CAMELLIA PARK SUBDIVISION

APPLICATION NUMBER 4 DATE April 19, 2007

REQUEST Subdivision

DETAIL SITE PLAN

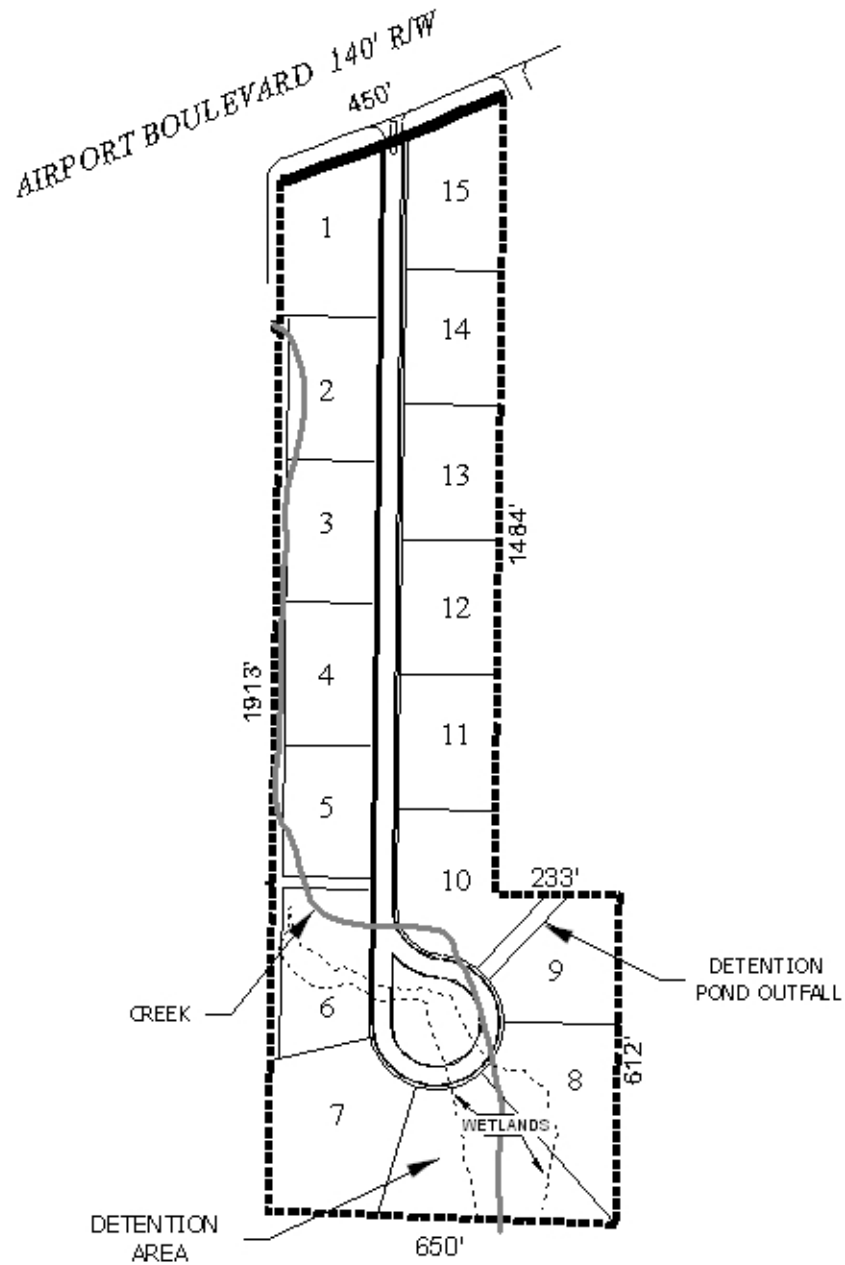
Airport Boulevard, which is shown as a major street on the Major Street Plan component of the Comprehensive Plan; and as such, requires a minimum right-of-way of 140-feet. The plat does indicate the minimum right-of-way width along Airport Boulevard and 50-feet of right-of-way for the new street within the site.

As Airport Boulevard is a major street, access management is a concern. Given the location of the existing curb-cut of the adjacent properties and median cut along Airport Boulevard, the relocation of the proposed street should be adjusted to provide as much distance between the new street and Baker High School as practical, and denying Lots 1 and 15 direct access to Airport Boulevard should be required. Also, any new road for the site is to be dedicated and constructed to meet County Engineering Standards, including the dedication of a sufficient radius at Airport Boulevard and the new street as determined by County Engineering.

The site illustrates wetlands on a portion of the site and since the presence of wetlands are indicated on the preliminary plat the area may be environmentally sensitive; therefore, the approval of all applicable federal, state and local agencies would be required prior to the signing of the Final Plat.

An area is shown on the preliminary plat along the western boundary with a 20-foot access from the new street and a 30-foot access between Lots 9 and 10, thus a note should be placed on the Final Plat stating that maintenance of the common area will be the responsibility of the property owners.

The 25-foot minimum building setback lines, required in Section V.D.9., are not shown, but would be required on the final plat.

The plat meets the minimum requirements of the Subdivision Regulations and is recommended for Tentative Approval subject to the following conditions: 1) the location of the proposed street be adjusted to provide as much distance between the new street and Baker High School as practical; 2) the placement of a note on the Final Plat denying Lots 1 and 15 direct access to Airport Boulevard; 3) the dedication of appropriate radii and the intersection of Airport Boulevard and the new street as determined by County Engineering; 4) labeling of each lot with its size in square feet, or provision of a table on the plat with the same information; 5) placement of a note on the plat stating that approval of all applicable federal, state and local agencies is required prior to the signing of the Final Plat; 6) provision of a certification letter from a licensed engineer to the Planning Section of Urban Development and the Mobile County Engineering Department, certifying that the stormwater detention and drainage facilities comply with the City of Mobile stormwater and flood control ordinances prior to the signing and recording of the final plat; 7) placement of a note on the Final Plat stating that any lots which are developed commercially and adjoin residentially developed property must provide a buffer, in compliance with Section V.A.7. of the Subdivision Regulations; and 8) the depiction of the 25-foot minimum building setback lines along Airport Boulevard and the new street.
